SSD 5207 - Netball Central : Site 107 Sydney Olympic Park Response to Issues raised in Submissions

Issue	Response	
Sydney Olympic Park Authority – Submission dated 24 Augus	st 2012	
Forecourt Design	It is understood that the issues around the forecourt design are largely resolved (refer Scott Carver drawing package attached), with the exception of the final lighting design (see comments below) and other relatively minor issues (balustrade detail for ramp).	
	It is understood that resolution of these matters will be discussed at a further workshop session with the Project Team and SOPA officers (which may achieve further resolution) but will ultimately be addressed via conditions of consent (to be recommended by SOPA).	
Signage Venue identification and way finding signage has not been shown as part of this application and it is recommended that venue and wayfinding signage be considered under a separate application.	The provision of way finding signage is a matter for SOPA and it is understood that it will ultimately serve the Sports Centre, Netball Central and any future development on the adjacent Site 13. Provision has been made for location of way finding signage within the for

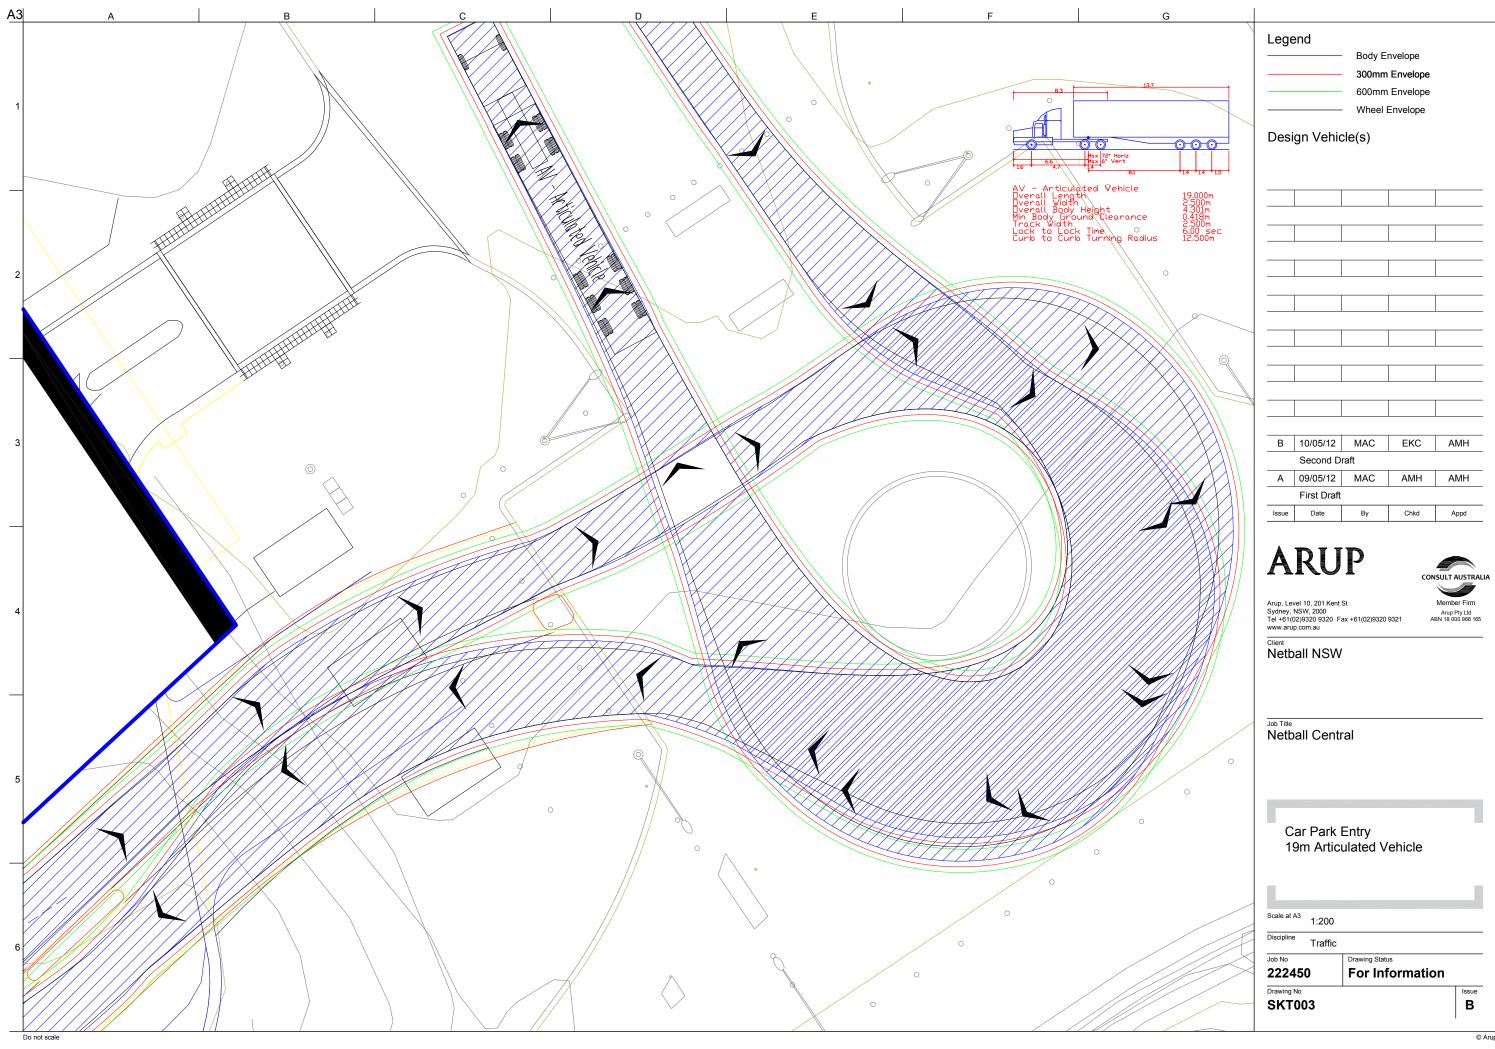
Issue	Response
4.1(c) avoiding adverse impacts on water quality or quantity in local streams, wetlands and groundwater from operations, developments, and major event activities at Sydney Olympic Park.	Having regard to the above, it is considered that the proposed development has demonstrated due consideration for the provisions of the SOPA Act and the requirements set out in the Environmental Guidelines.
The proposal as submitted is not consistent with the SOPA Environmental Guidelines with respect to stormwater management as the proposal does not currently address inclusion of a stormwater collection and recycling system, and impacts on receiving waters and on downstream flooding are not assessed (the EIS states that further modelling and quantitative assessment is yet to be undertaken).	
The Preferred Project Report should address the following:	
The application is to show compliance with the SOPA Act.

In relation to section 4.1(c) regarding water quality or quantity, water quality devices

and on-site detention has been designed to avoid adverse impacts on both quality

and quantity of water in Boundary Creek (refer Attachments 2 and 4).

Draft site drainage layout drawing

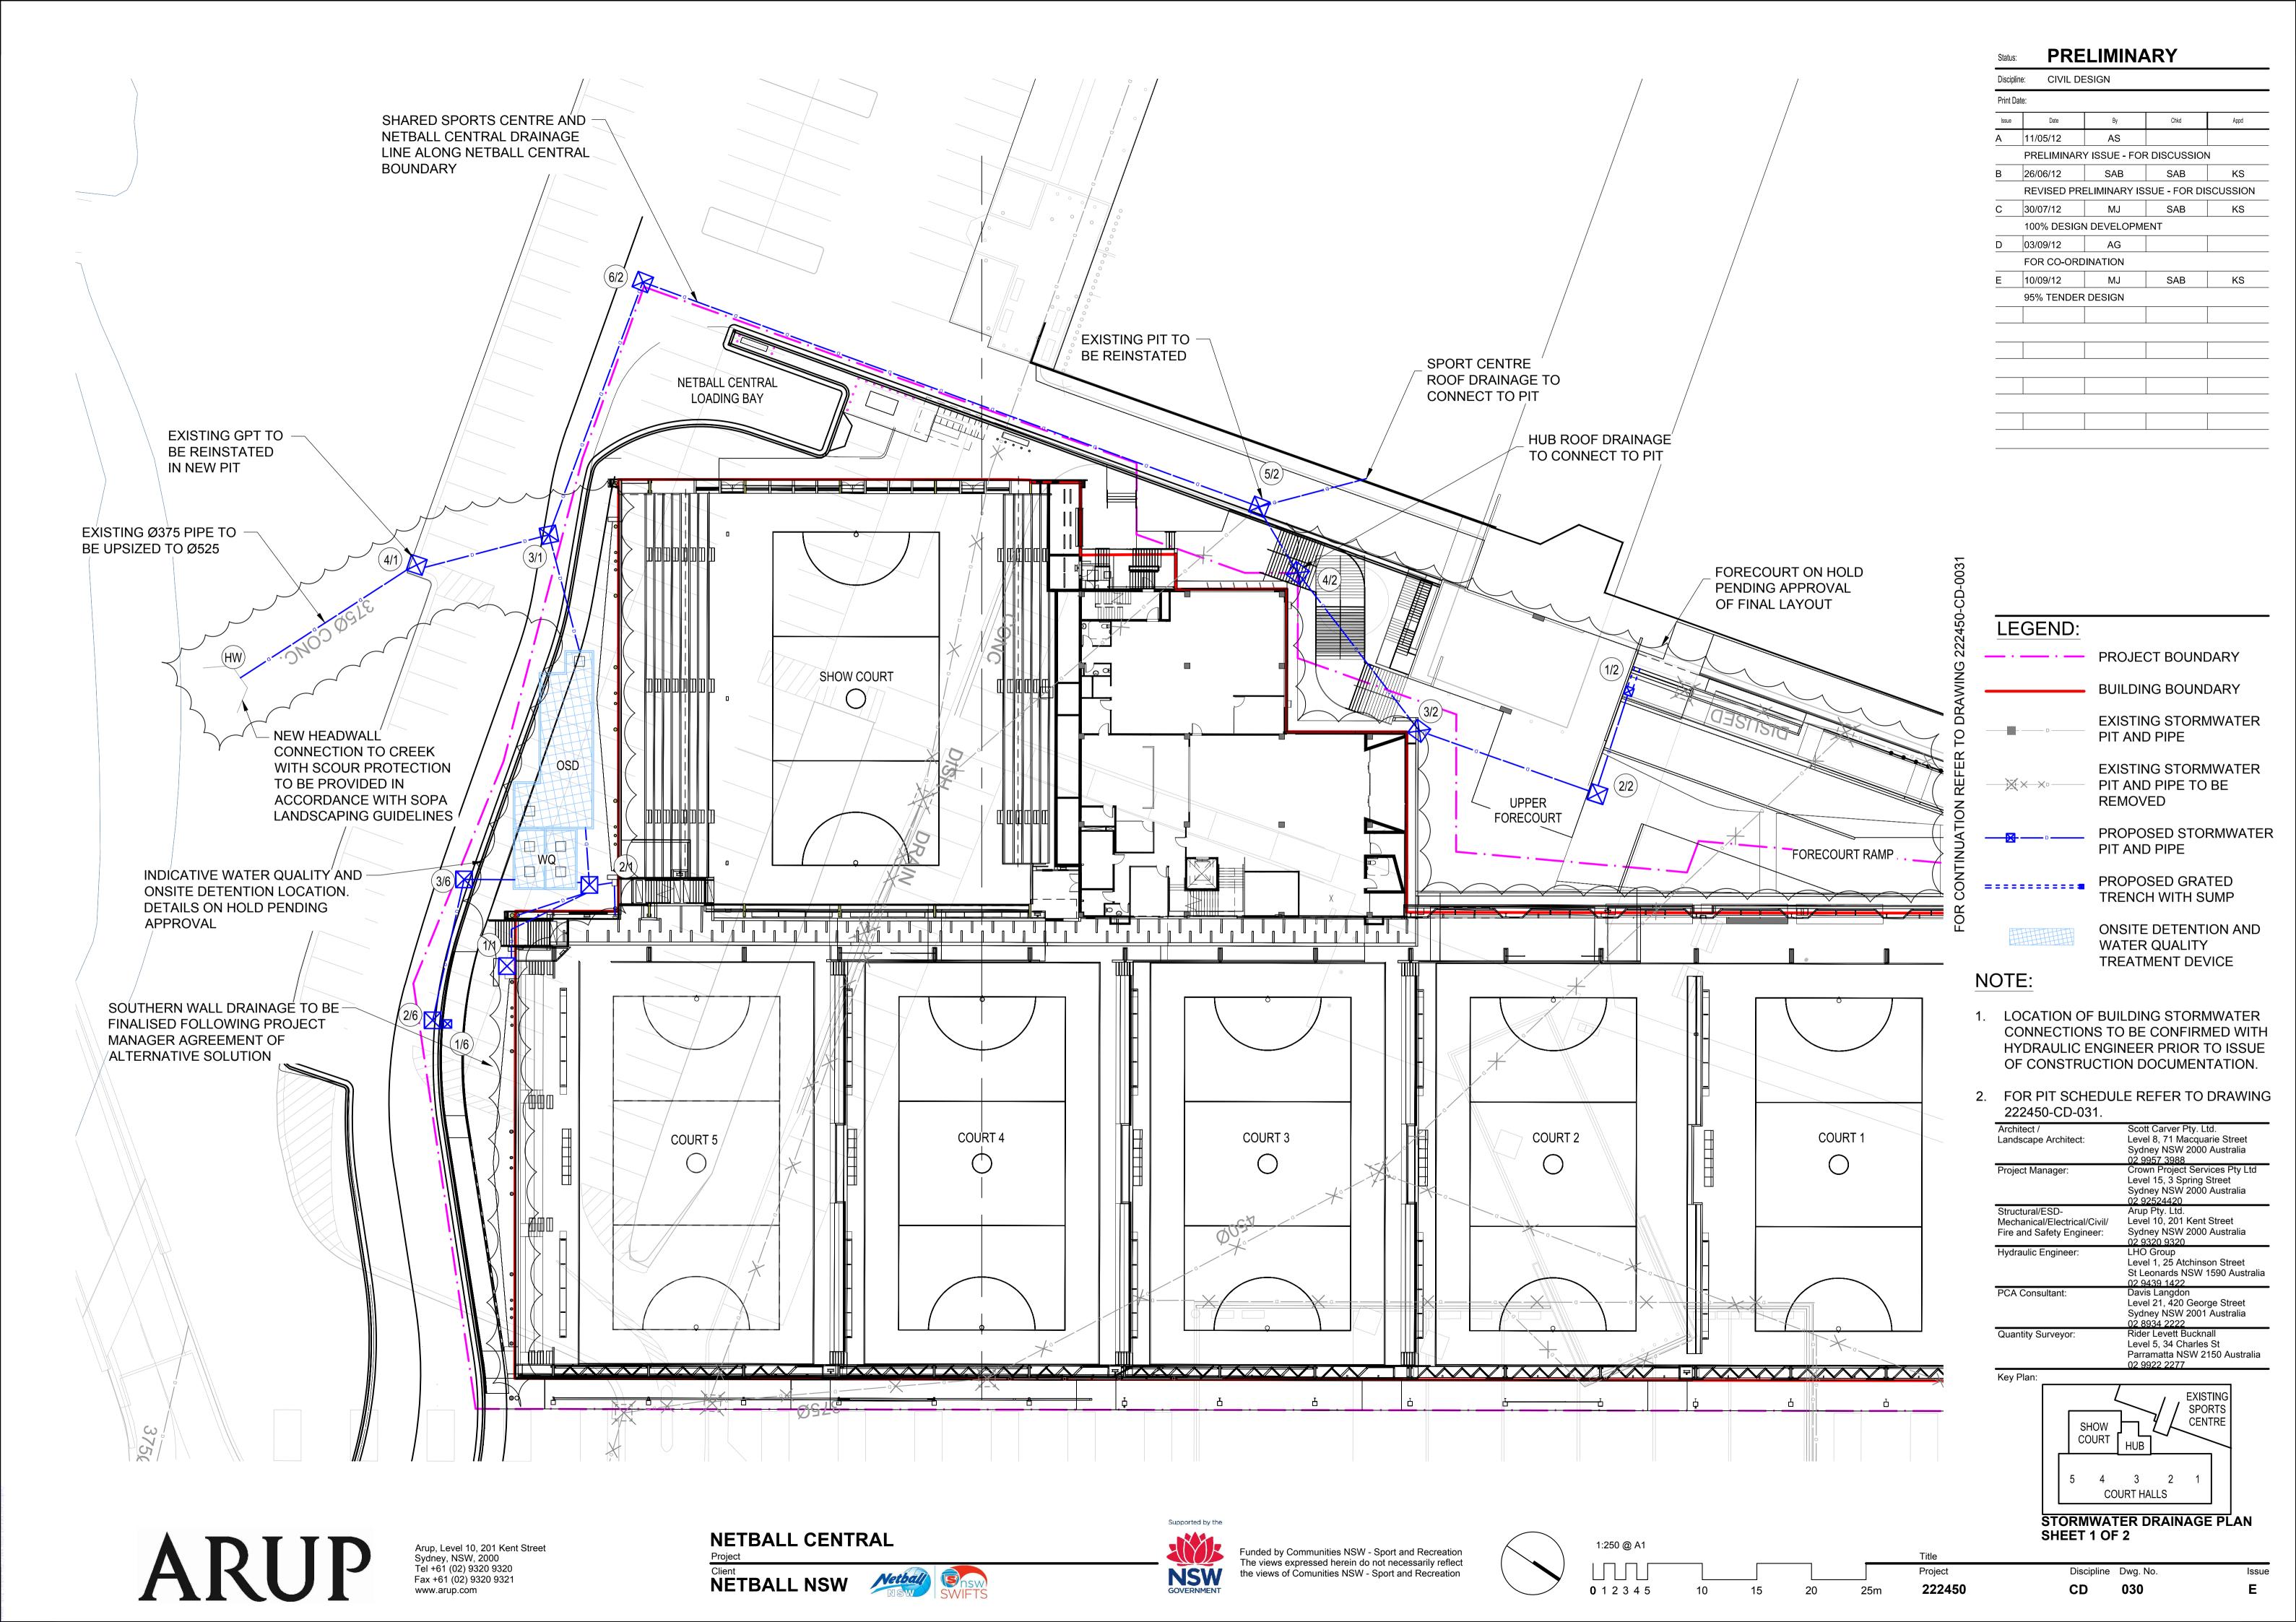
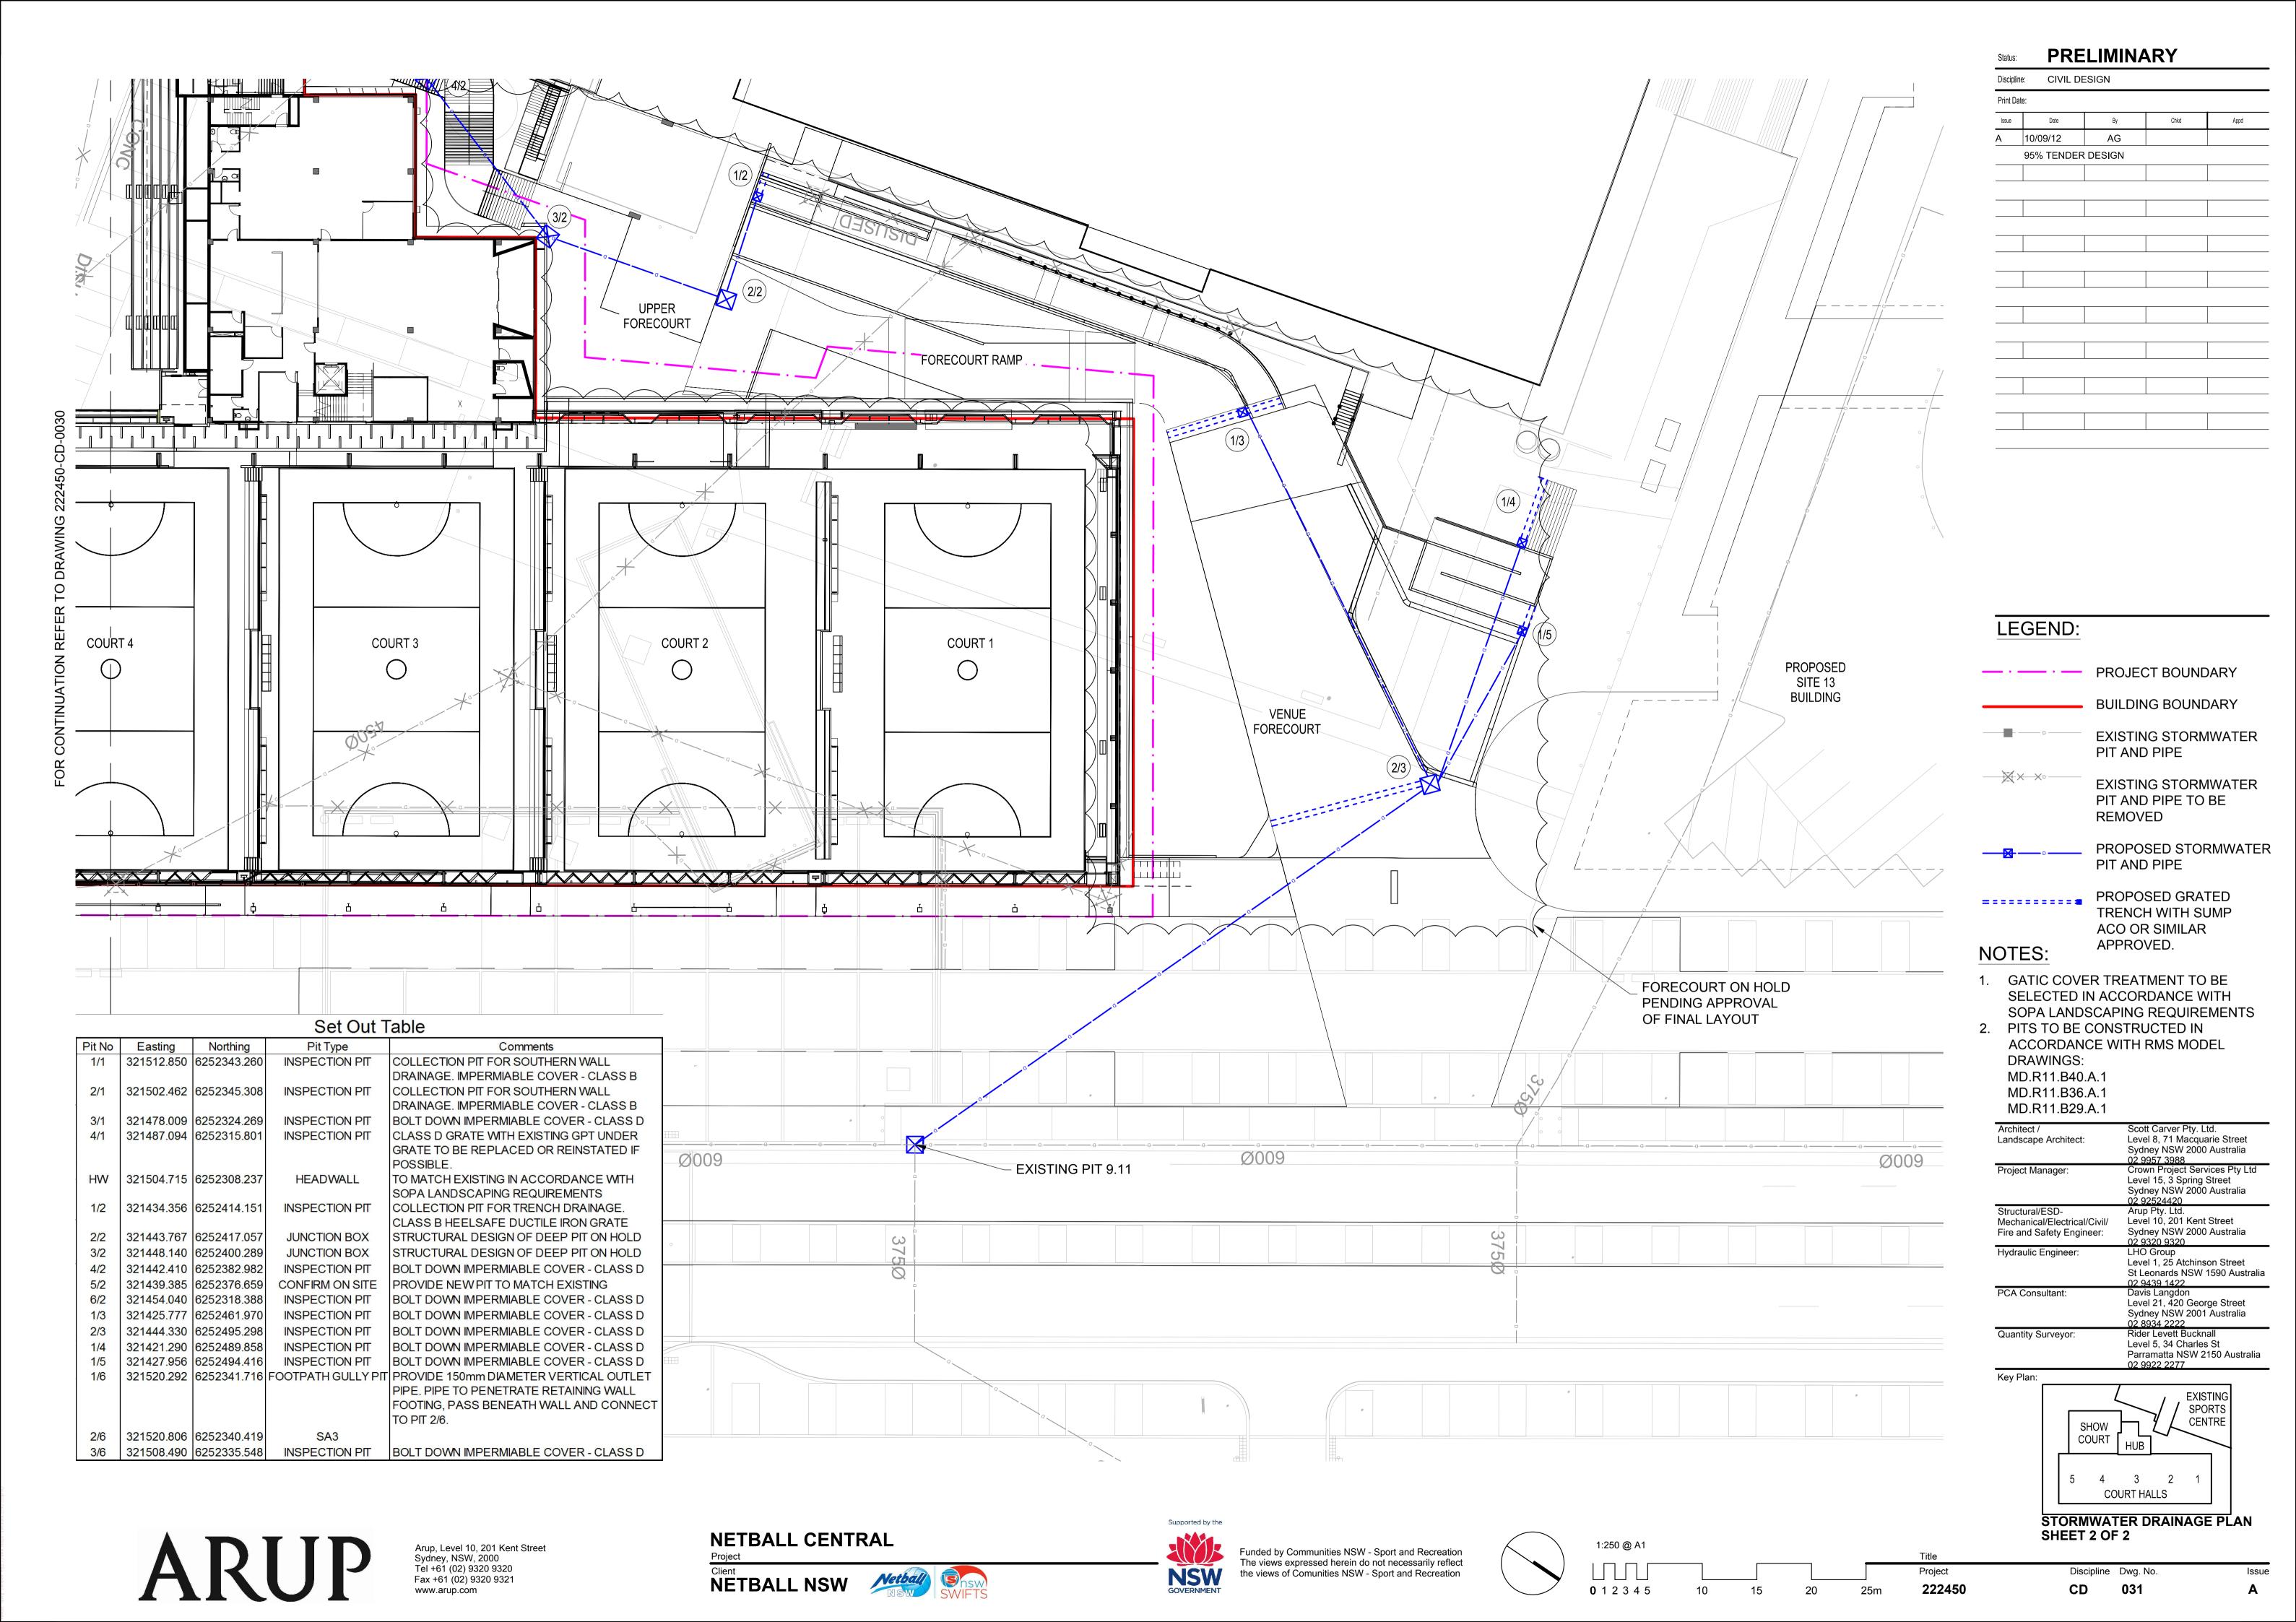
Issue	Response
Stormwater	
The proposed stormwater drain / detention channel on the southern side of the Netball Centre is both dangerous and unsightly and is not supported by SOPA. In addition, the submission does not demonstrate that thi channel has the capacity to provide adequate on-site SW detention.	Attached for SOPA's information is the following information: Details of proposed on-site detention prepared by ARUP (refer Attachment 2); An alternate solution for the integration of roof drainage and the treatment
Roof drainage is not well resolved, with an excessive number of downpipes dominating the southern face of the building.	of the southern elevation of the building is illustrated at Attachment 3 prepared by Scott Carver Architects; and
Harvesting / reuse of this stormwater (eg. for toilet flushing, irrigation) is not currently proposed, with all rainwater collected from the substantial new roof area ultimately intended to flow to Boundary Creek (EIS p73).	Advice from ARUP regarding water quality (refer Attachment 4).

Under this scenario, upgrade of drainage outlets in BoundaryCreek is liekly to be required to provide for peak flows; the need and responsibility for such works is not identified in the EIS. The EIS identifies that on-site detention of stormwater is required to comply with SOPA's Draft Development Control Policy: Water Sensitive Urban Design, and that ARUP is undertaking further modelling and quantative assessment, with the size and location of the storage to be determined during detailed design (EIS p73).	
Stormwater management and reuse plans are integral to project design and impact assessment; the EIS is incomplete and potential impacts not able to be properly assessed without such information being provided.	
The Preferred Project Report should address the following:	
 A detailed Stormwater Management Plan is to be prepared and is to include calculations to demonstrate that the system can manage expected flows; Further design refinements are to be made to integrate roof drainage into the overall design of the building. Any required open channels are to be screened, covered or integrated into a coordinated landscape solution; Harvested stormwater should be reused (eg. for toilet flushing) rather than discharged, to minimise flow impacts to Boundary Creek from the proposed development.

Arup have produced a draft site drainage layout plan, which shows the preliminary location of stormwater On-Site Detention (OSD) and water quality treatment measures. The drawing also depicts the locations of existing and proposed stormwater discharge structures (headwalls).

The drawing has been provided in Appendix C. It should be noted that this site drainage layout drawing is current at the time of writing. However, it is expected that the drainage layout will evolve as the scheme progresses; hence this plan represents the intent of network rather than the final drainage arrangement.
